From: Julie Grieves
Sent: 06 December 2013 09:27
To: 'bryan.butcher@btopenworld.com'
Subject: RE: Further Information Required on Your Ref: N/A Our Ref: AW/313/13/

From: bryan.butcher@btopenworld.com
Sent: 05 February 2014 14:10
To: Karen Garner
Subject: AW/313/13
Attachments: SCAN_20131205_195923371.pdf

block plan

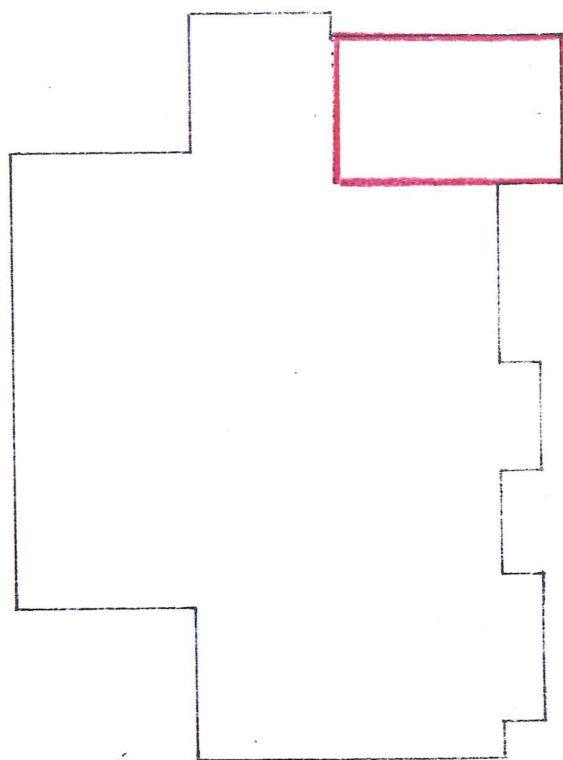
Thank you for your email and attachment. The block plan must have at least one named road and show adjoining properties.

Just looking at the block plan 1:200 sent it hasn't got a road name on it but the previous block plan 1:500 submitted with the application has!

Nicola spoke to
Mr Butcher. He will
send a new block
plan.
K 5/2/14.
